SEPTIC IMPROVEMENT PERMIT / AUTHORIZATION TO CONSTRUCT / OPERATION PERMIT / EXISTING SYSTEM

PERMIT # 314442

333 S SAN AGUSTINE DR, MOORESVILLE NC.
SECTION 4, LOT 159 BELLS CROSSING

LOT 159
BELLS CROSSING SUBDIVISION
MOORESVILLE, NC
IREDELL COUNTY

INITIAL SITE SKETCH

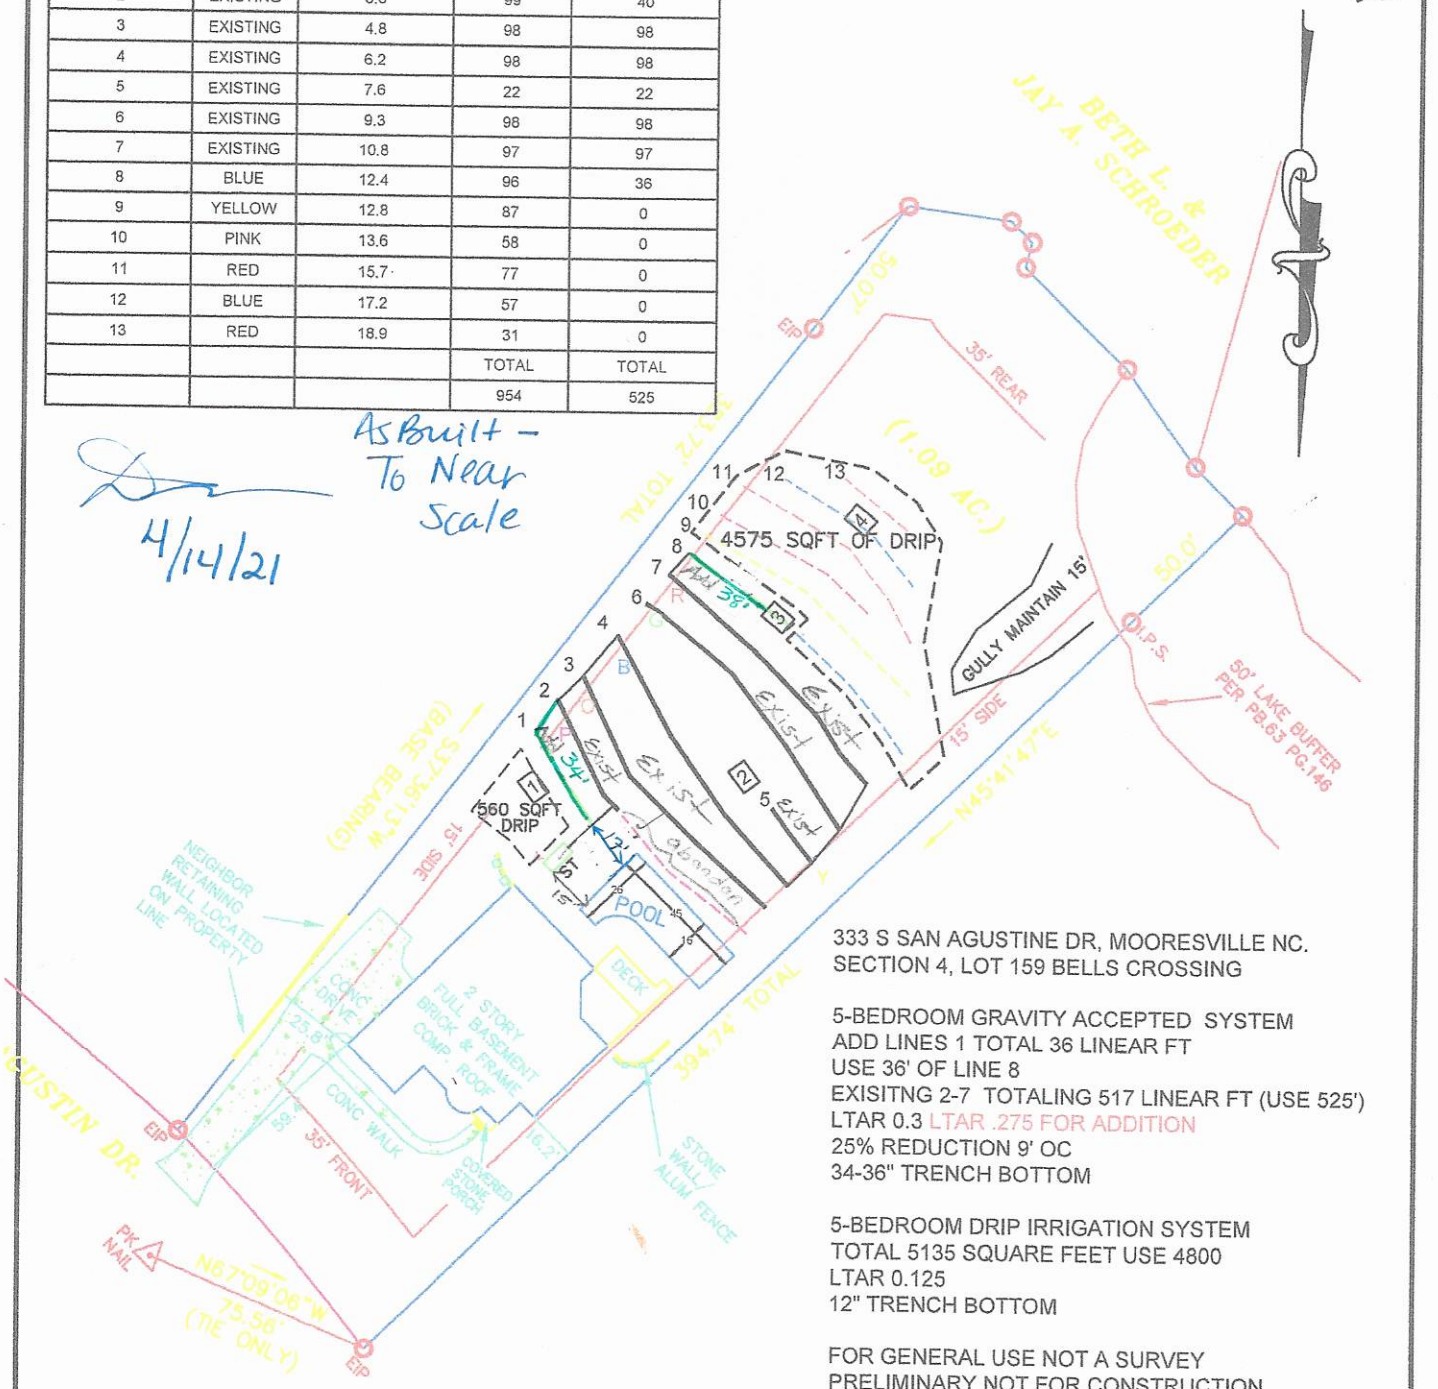
Comments / Conditions: Note: Abandon any part of existing Septic System that's ≤ 15 Ft from proposed pool. Supply line must be a minimum of 10 Ft from pool.

Add one 36' drainline above existing drainfield & one 36' drainline below existing drainfield. Abandon 59 ft of existing upper drainline

upper line over dug, excess area tamped down

333 S SAN AGUSTINE DR, MOORESVILLE NC.
SECTION 4, LOT 159 BELLS CROSSING

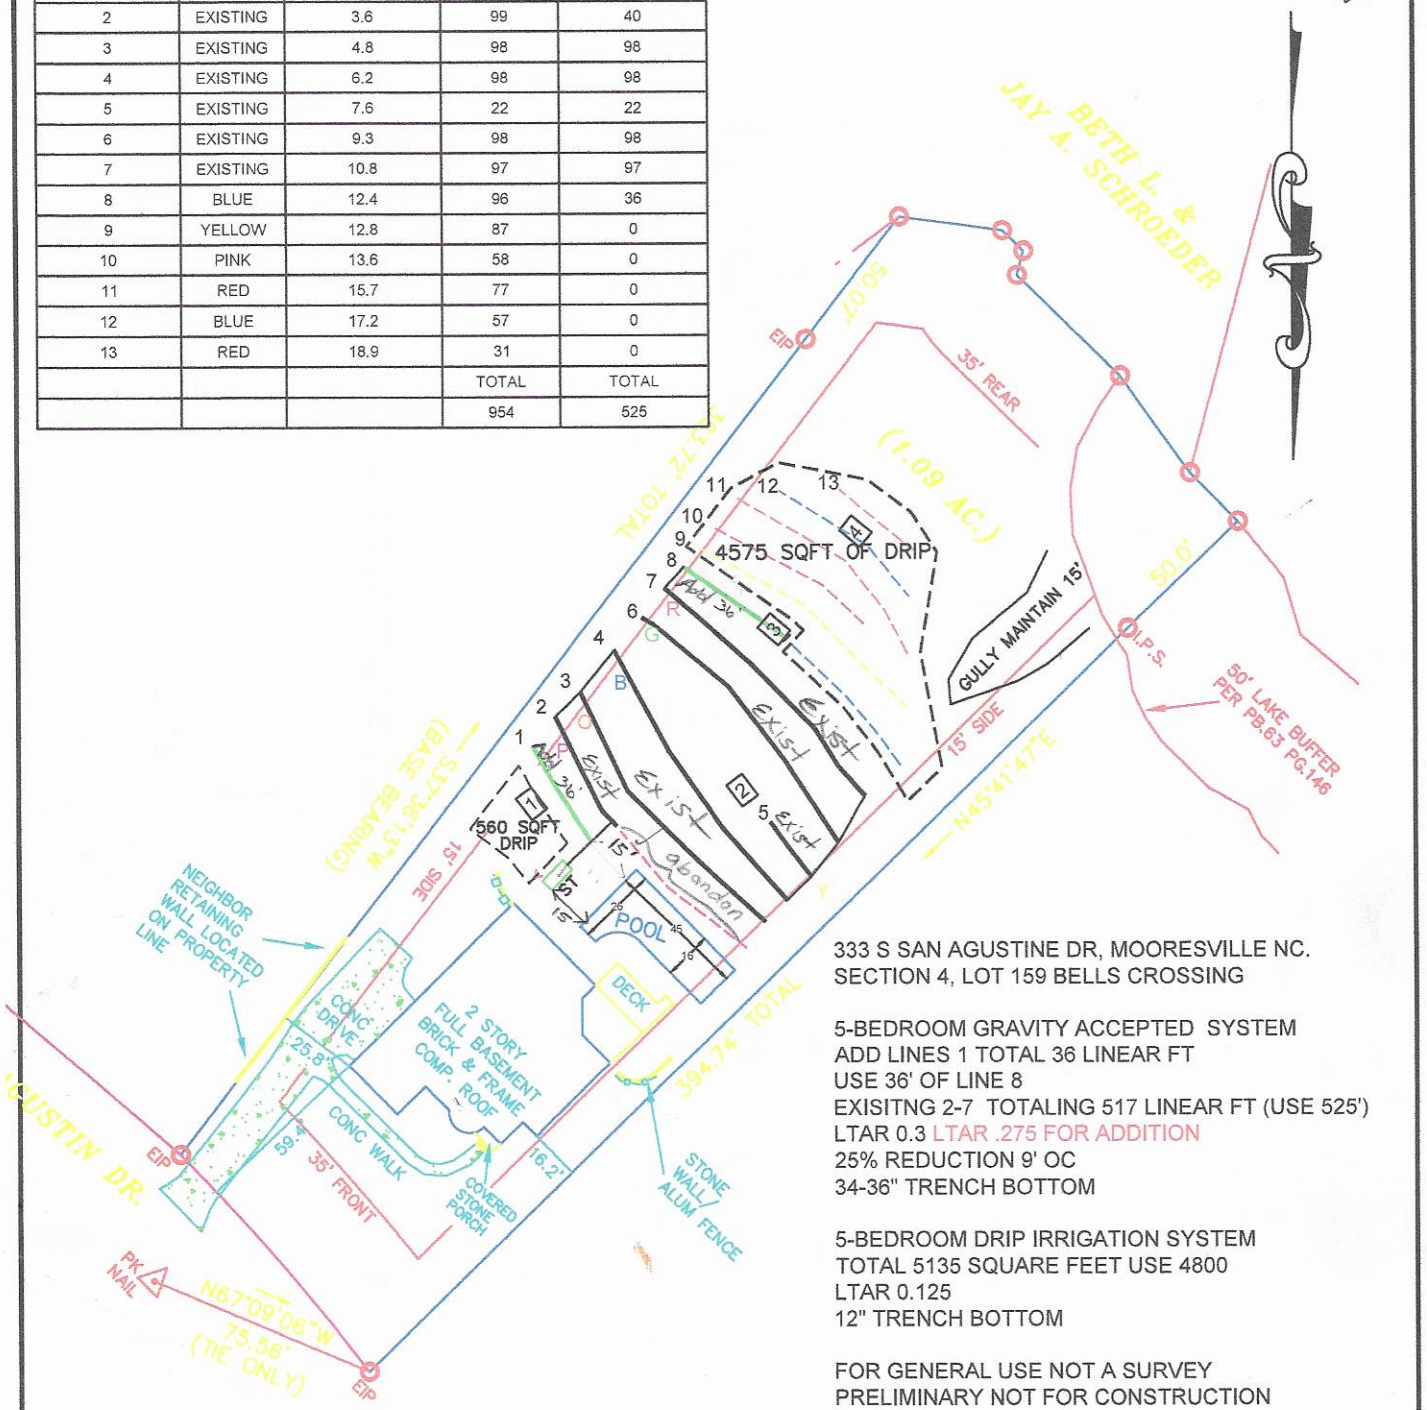
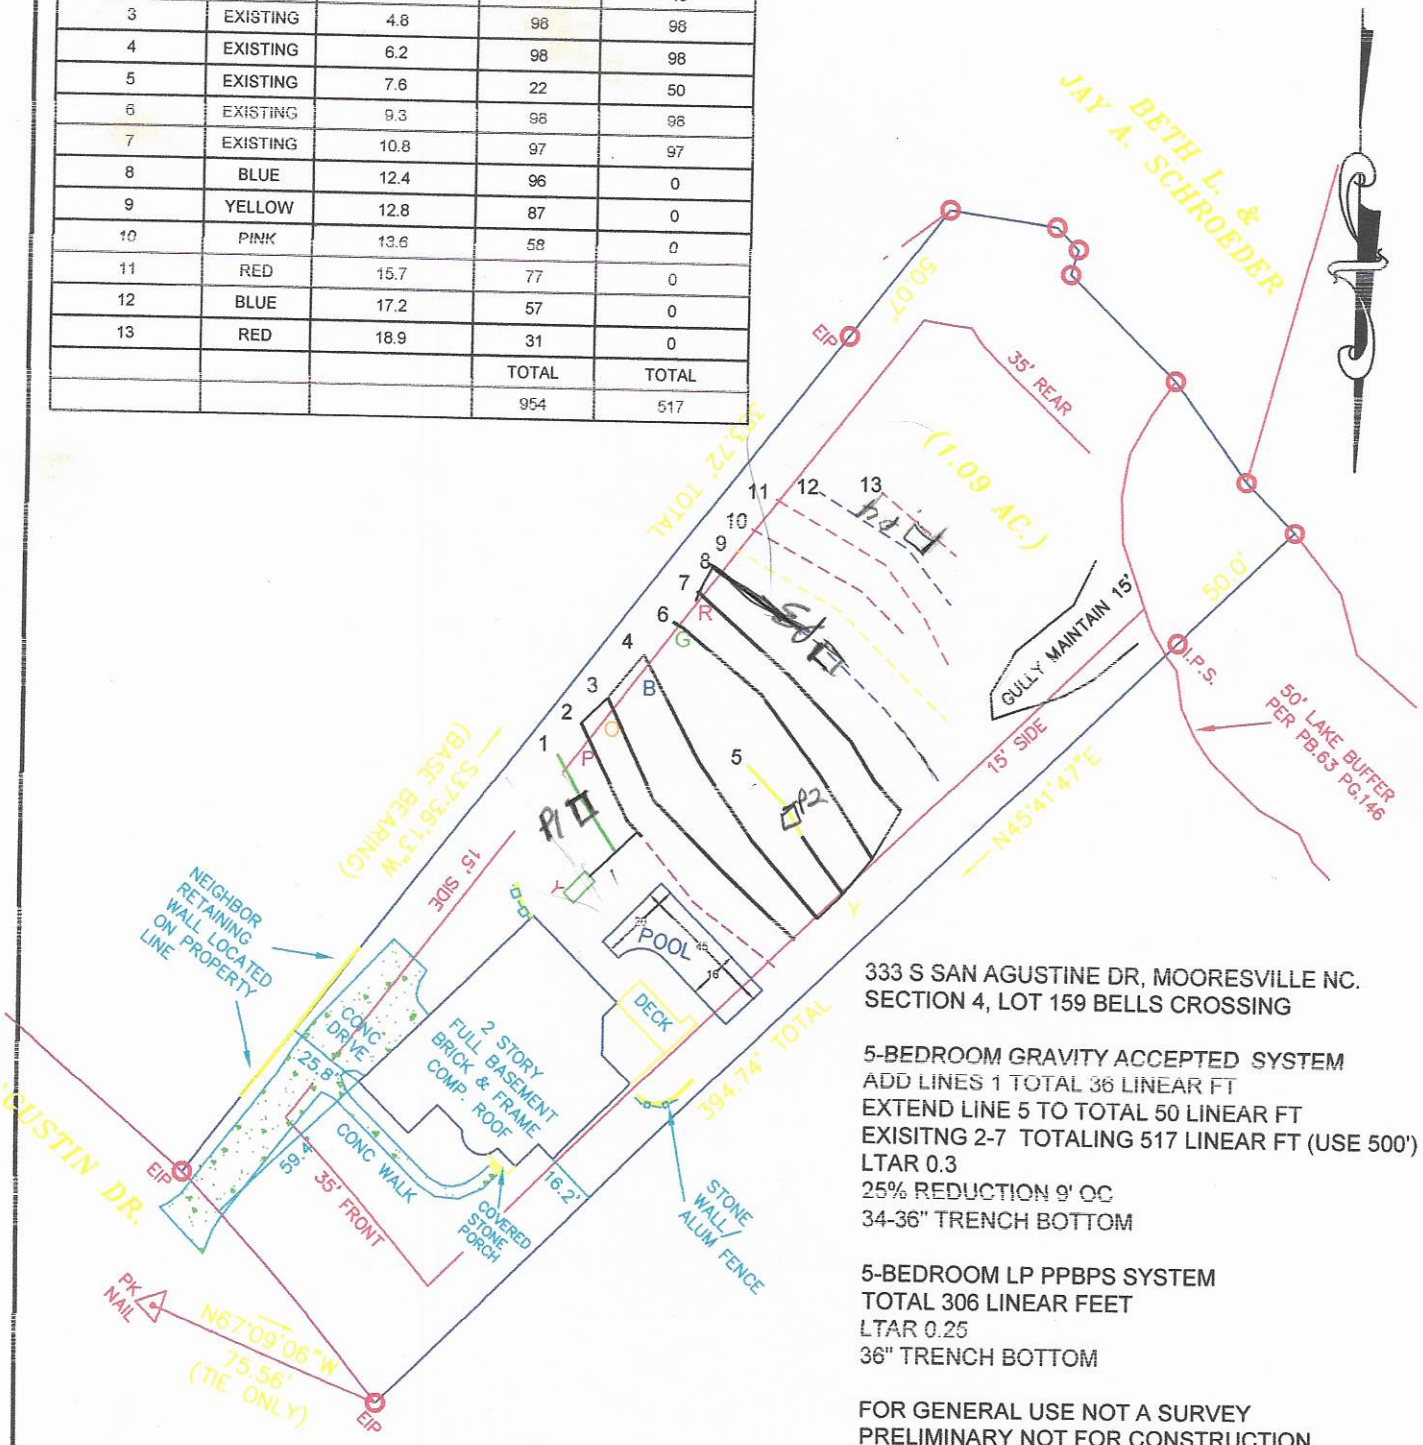
Notes: SOIL INFORMATION PROVIDED BY IREDELL CO
-DROP 59' FROM THE FIRST EXISTING LINE
-ADD 36' LINE ABOVE AND EXTEND LINES 5 BY 28'

Notes: SOIL INFORMATION PROVIDED BY IREDELL CO
-DROP 59' FROM THE FIRST EXISTING LINE
-ADD 36' LINE ABOVE AND INSTALL 36' OF LINE 8

5-BEDROOM GRAVITY ACCEPTED SYSTEM
ADD LINES 1 TOTAL 36 LINEAR FT
USE 36' OF LINE 8
EXISITNG 2-7 TOTALING 517 LINEAR FT (USE 525')
LTAR 0.3 LTAR .275 FOR ADDITION
25% REDUCTION 9' OC
34-36" TRENCH BOTTOM

INITIAL SITE SKETCH

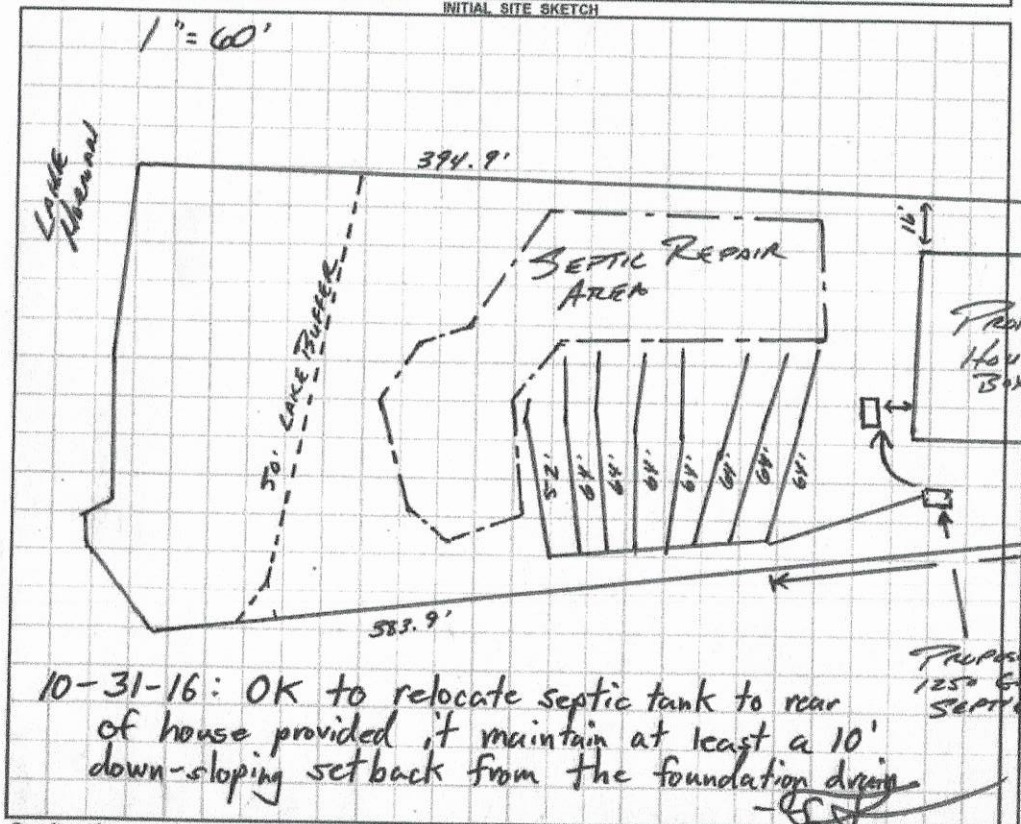
Comments / Conditions: Smooth Septic Area Upon Backfilling. If Repair Is Utilized Fill Will Have To Be Removed To Accomodate 36" Trench Bottom In Natural Soil With 6" Cover.

9-29-16: Proposed house 64'8" wide exceeds previous proposed house box width of 60'. Driveway turnaround may need to be narrowed by 3'8" → 4'8". -SS

AS BUILT SKETCH

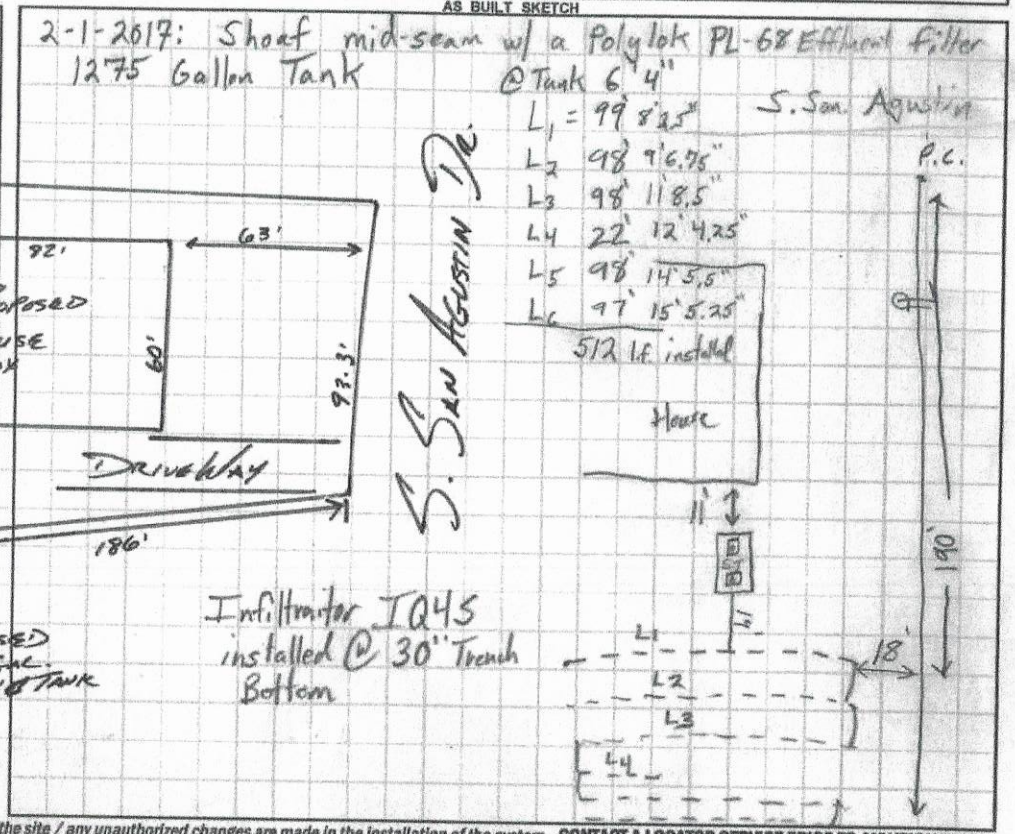
10-31-16: OK to relocate septic tank to rear of house provided it maintain at least a 10' down-sloping setback from the foundation drain -SS
